Access Compliance Report

Public Rights-of-Way

(Curb Ramps)

Intersection ID: 2555	Main Street: PELORUS_LN	Cross Street: TARBY_CT	Location: S
ADA ID: 1A37C8E38610	Ramp Type: PerpDiag	Initial Pass/Fail: Pass	Overall Compliance: No
Codes/Mitigation Info/Possible Solution		Field Measurements/Component Compliance

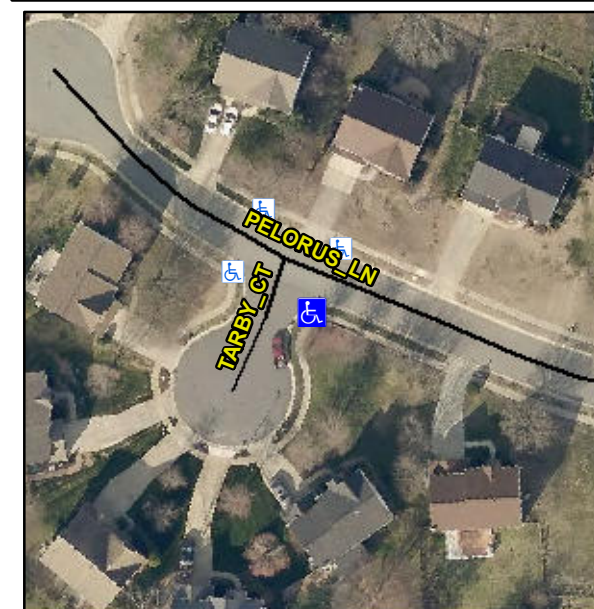
Remove & Replace Curb Ramp With Two New Directional Ramps or Equivalent. Remove & Replace Gutter.

R304.2.1, R304.2.2-Perp, R304.3.2-Para, R305.2, R304.5.3
